Adjustable Tubular P-Traps

Shop Drawing Submittal Review

Project Name: Webster University-**ISB**

SPEC SECTION: 22 4216.16
Commercial Sinks

PFPTB101

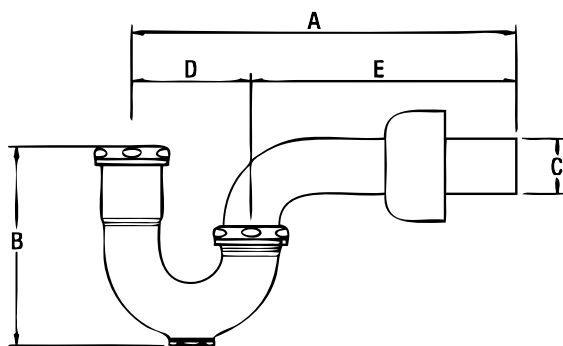
1. Provide under counter waste and supply protective piping covers as required.
Verify requirements with the architectural drawings.
2. Escutcheons are specified to be cast brass. Refer to specification section 220518.
